Permit No: PRRES20210293
Plan Name: 3022 NW THOREAU PL
Project Address: 3022 NW THOREAU PL, LEES SUMMIT, MO 64081
Parcel Number: 225580
Location: WINTERSET VALLEY 13TH PLAT LOTS 1472 THRU 1487 --- 1475
Type of Work: NEW SINGLE FAMILY

Residential Plan Review

LANNING RESIDENCE
LOT 1475 - WINTERSET VALLEY
3022 THOREAU PLACE
LEE'S SUMMIT, MO 64081

FRONT ELEVATION
SCALE: 1/4" = 1'-0"

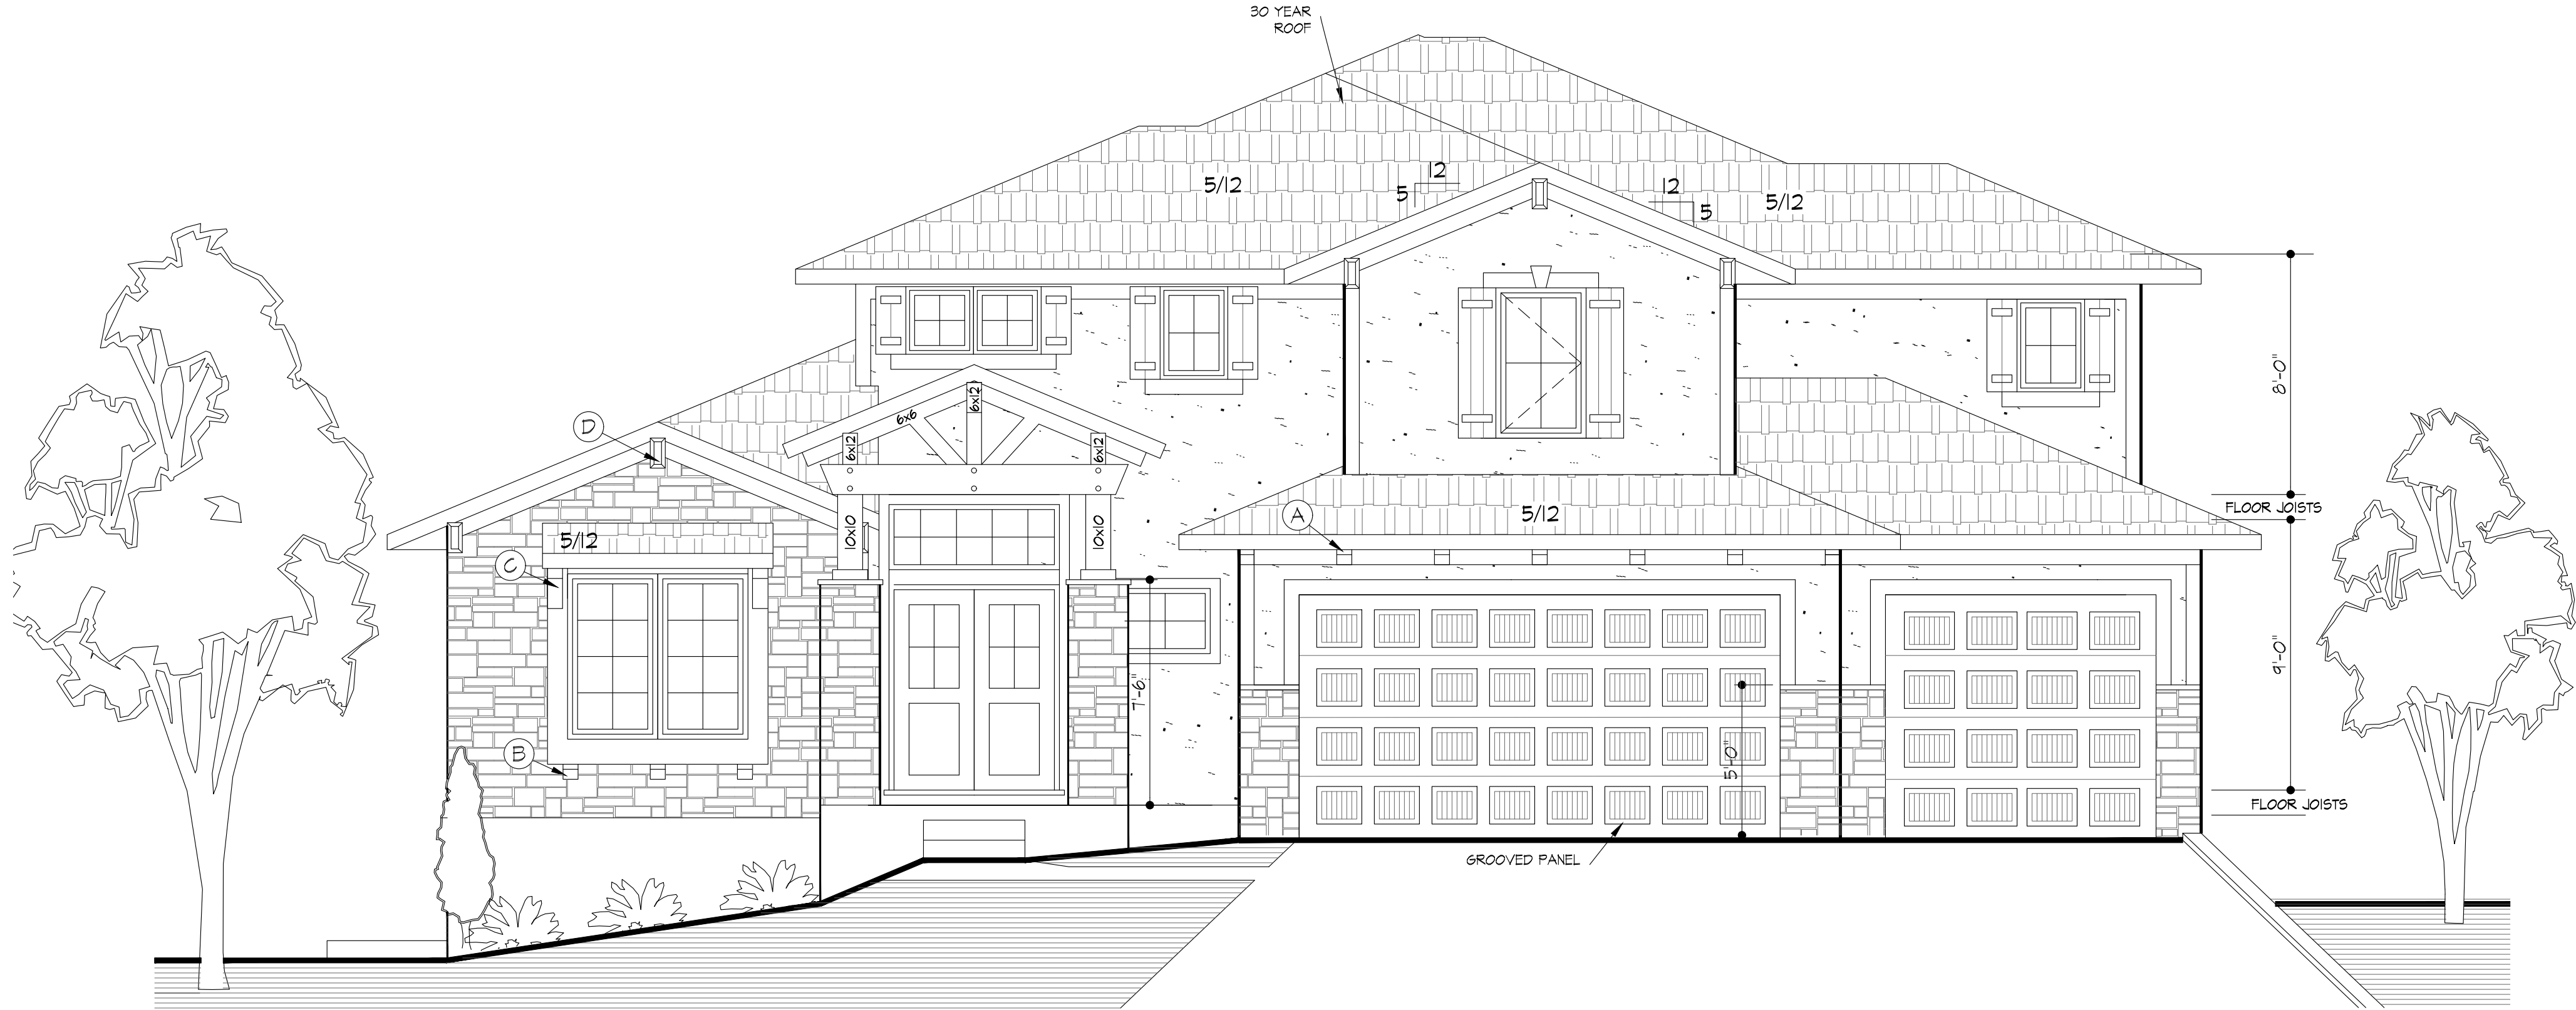
1. Identify roof covering material (IRC Section R905)

SEE CLOUDED FRONT ELEVATION

MAIN FLOOR PLAN

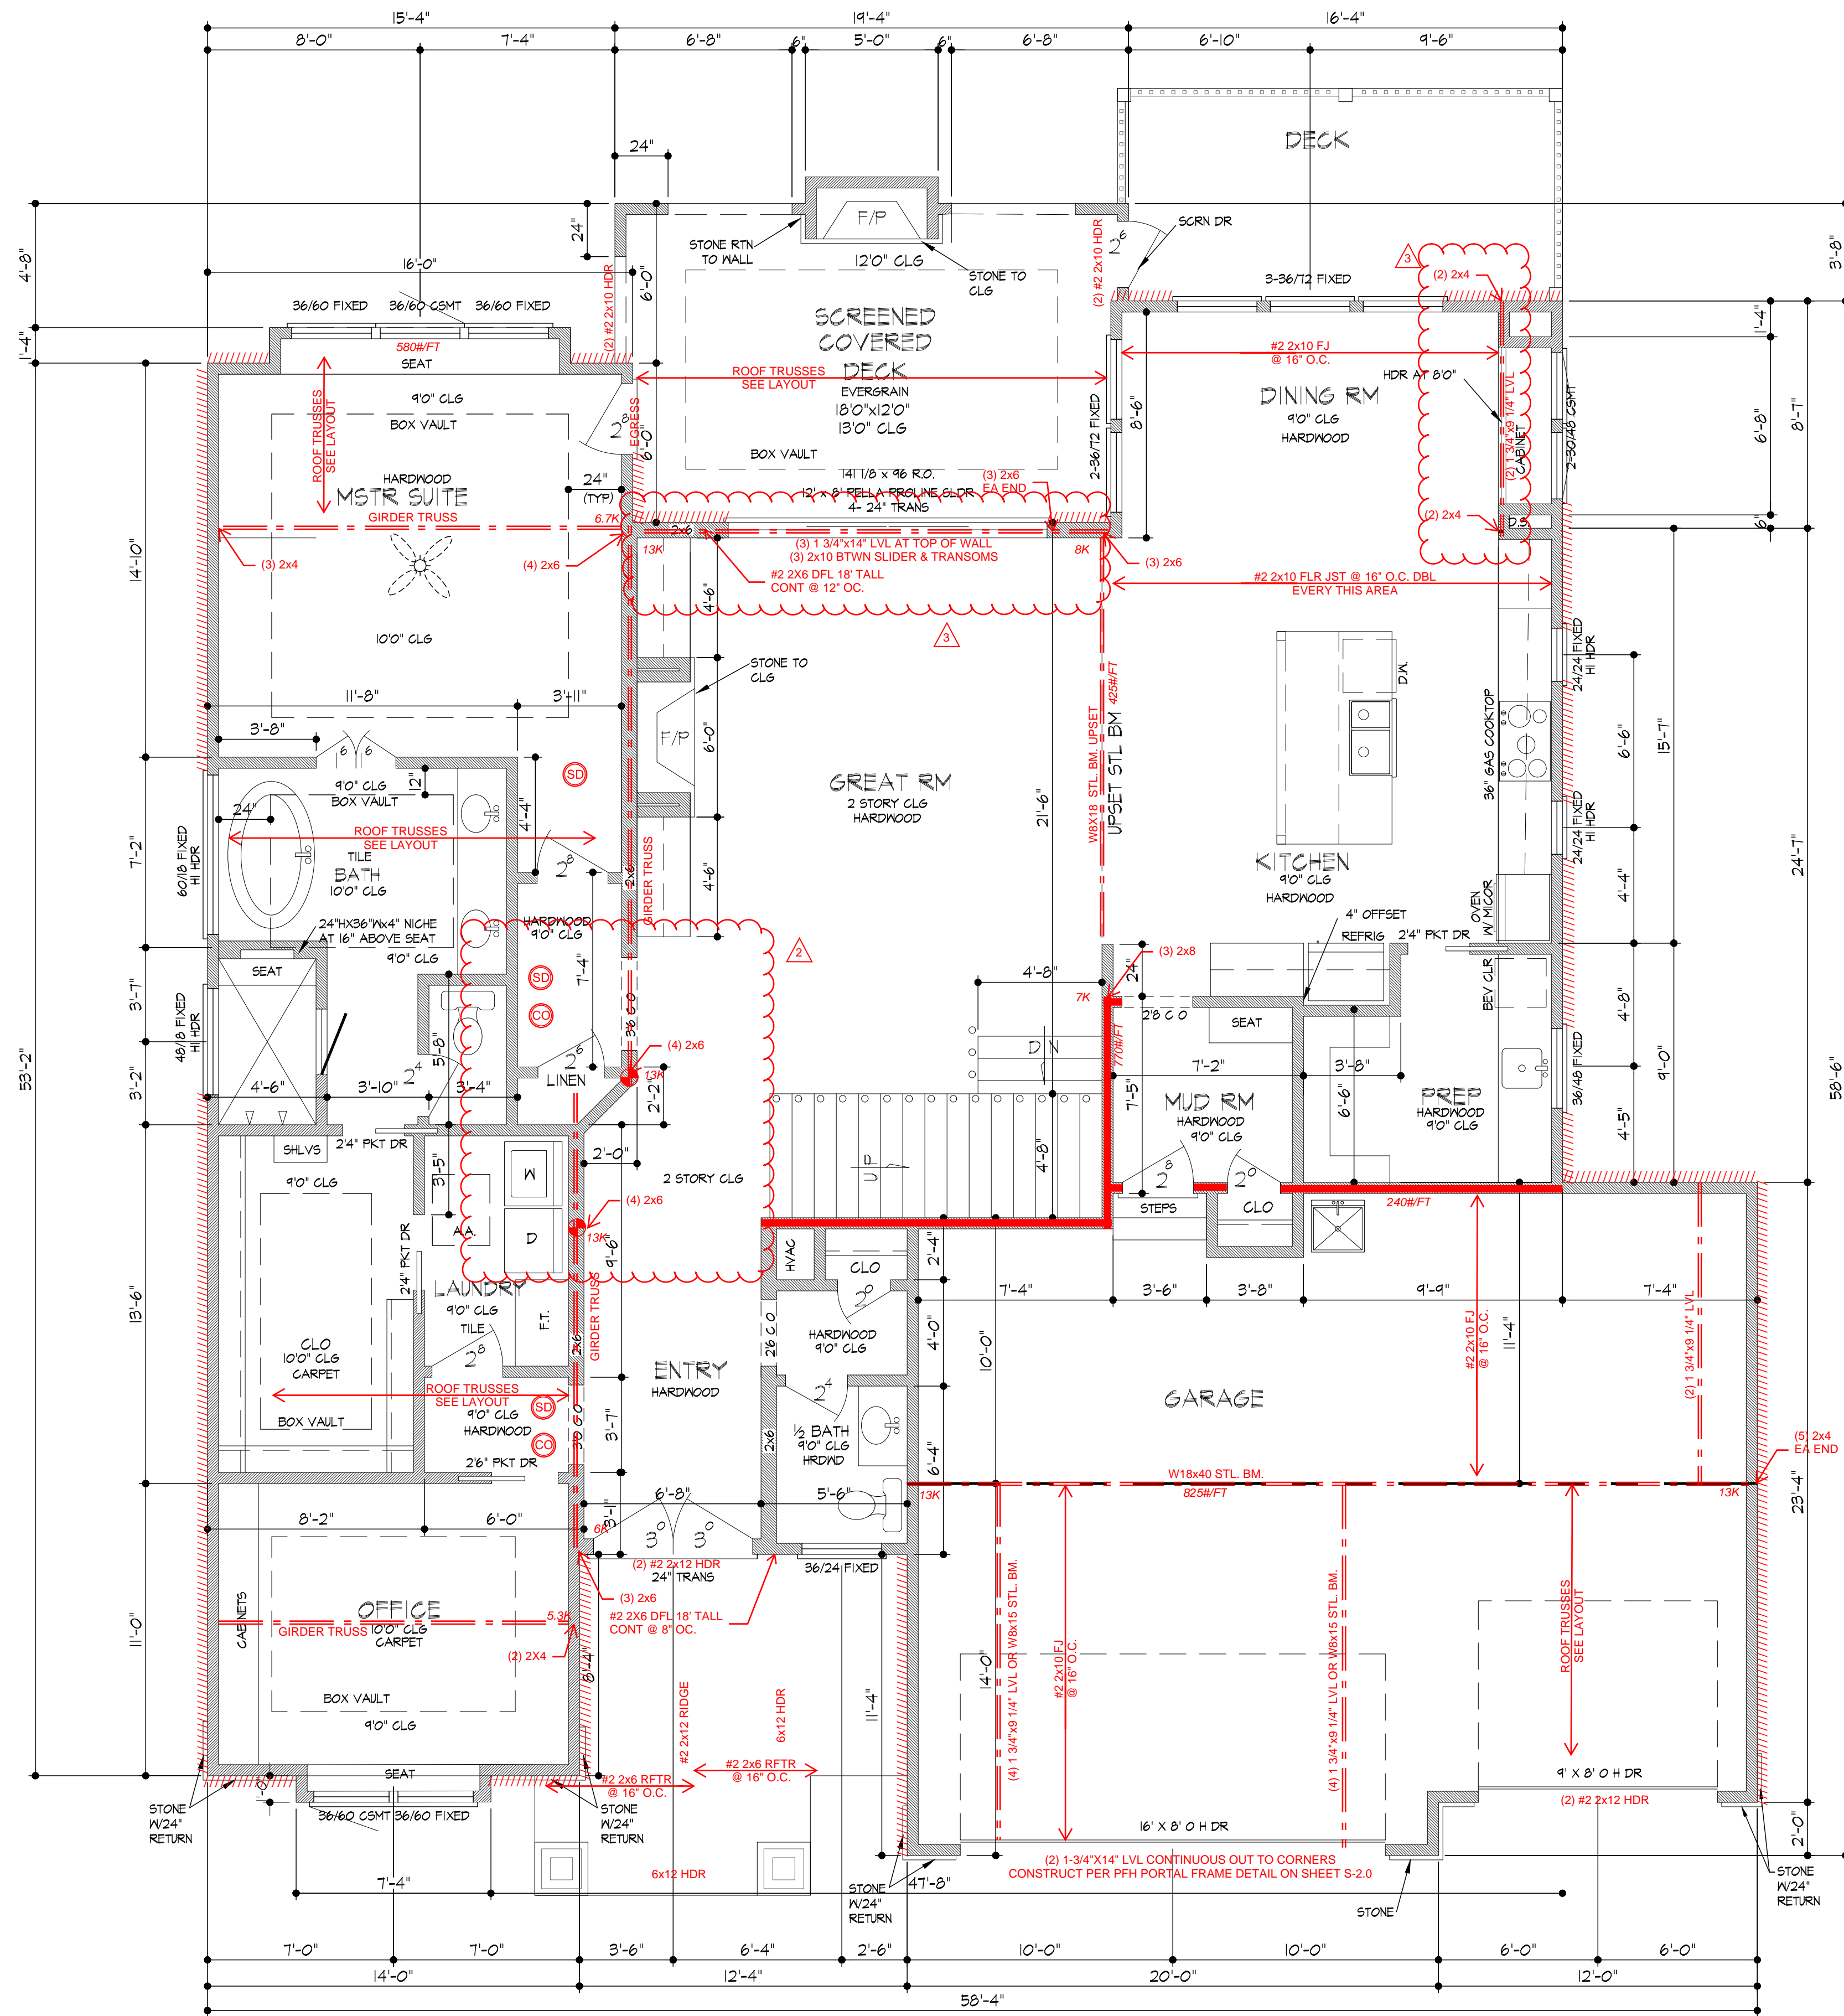
2. Identify braced wall locations and length of braced wall panel(s). (IRC Section R602.10)

SEE CLOUDED PLAN CHANGES
